WeMo Switch V2

CMF AND PRINT GRAPHICS

REVISION: 2.4

DATE: 2016-08-24

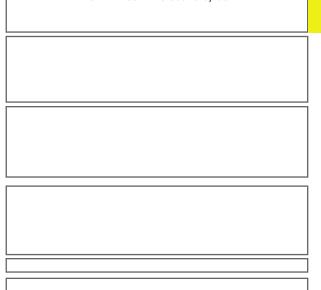
v2.1 - Adjusting certification print graphics to match new sized label recess.

Added FCC/IC ID numbers

v2.2 - Removed UL logo and adjusted layout.

Changed product name to "Mini".

Adjusted placement of Wemo logo on front.

v2.3 - Adjusted front texture to be slightly heavier. YS-20038 is replaced with YS-20048.

We are sending a product sample for reference. v2.4 - Adjusted copy for Factory restore.
